APPROVED
BY: [Signature]
COOK NUCLEAR PLANT
AMERICAN ELECTRIC POWER
SERVICE CORP.
MECHANICAL DESIGN DIVISION
SEP 14 1964

Westinghouse Electric Corporation
TAMPA DIVISION TAMPA FL
APPARATUS S1 SERIES STEAM GENERATOR
TITLE GENERAL ARRANGEMENT

1097J74

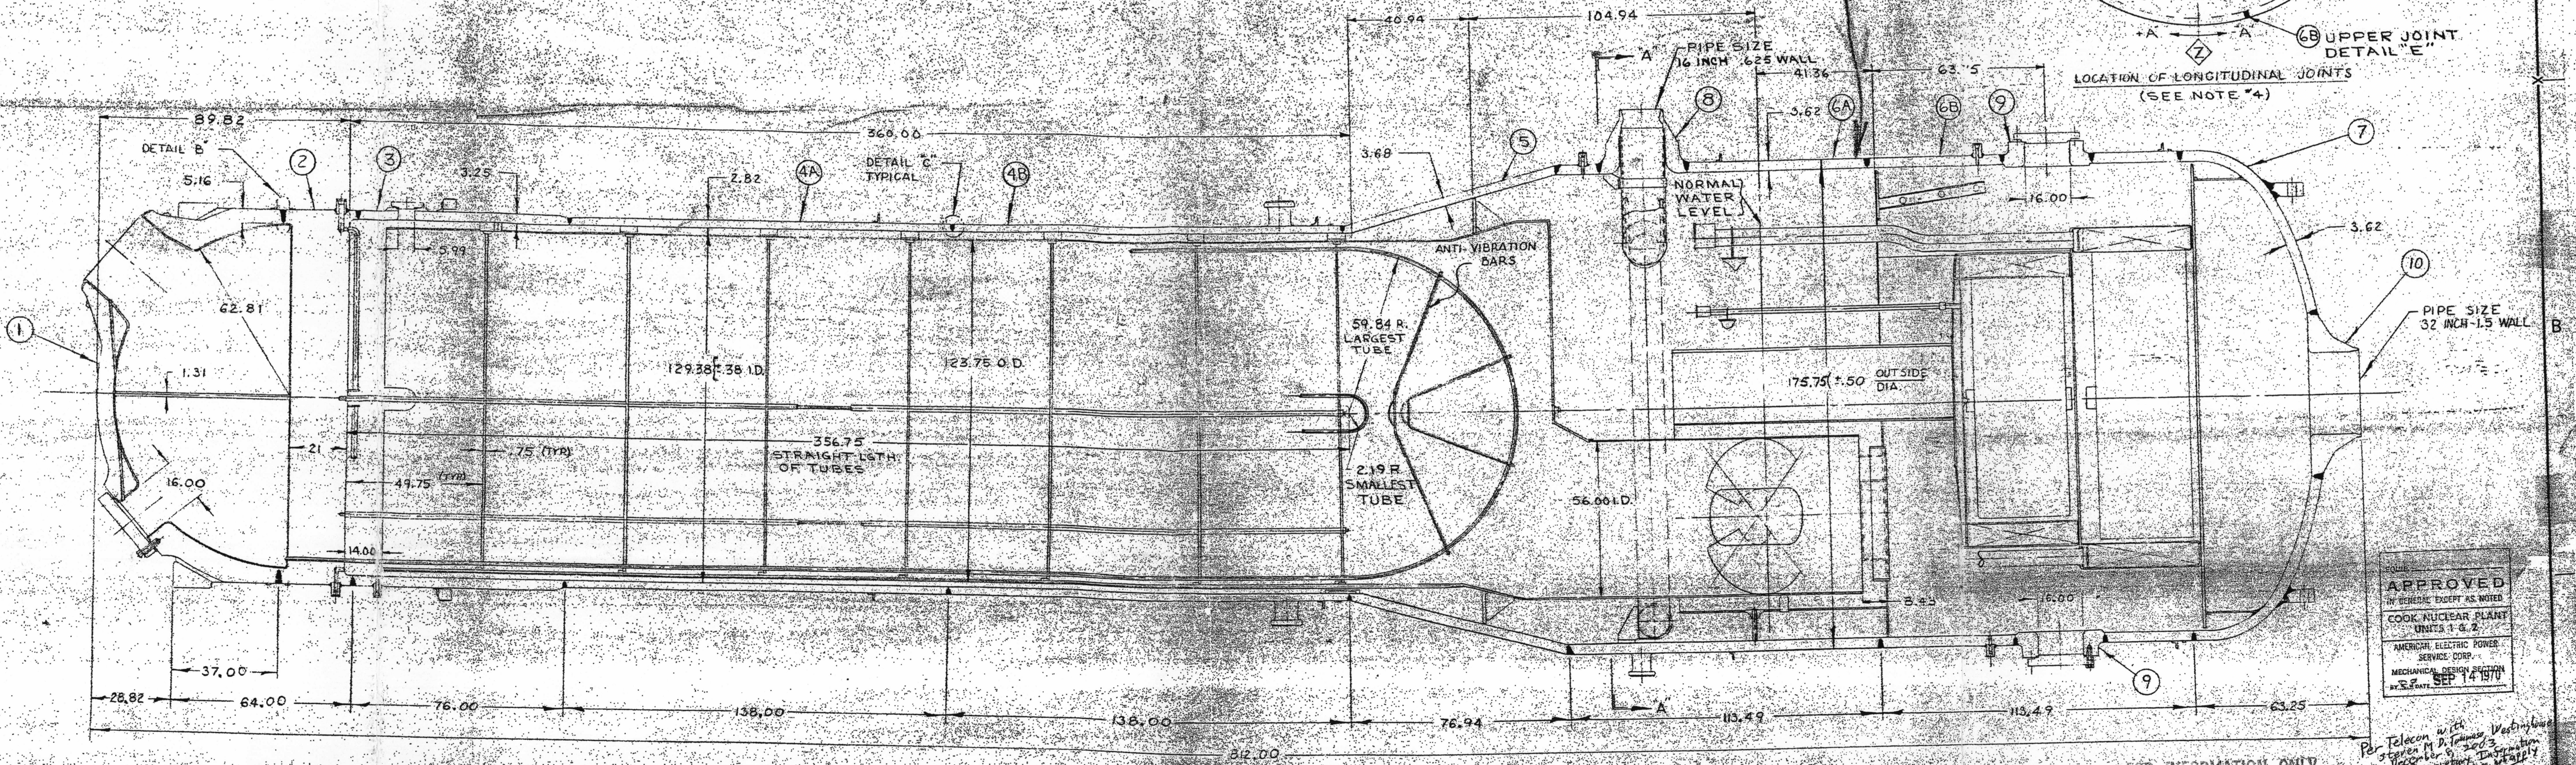
WHERE ARE THE SUPPORTING LUGS?
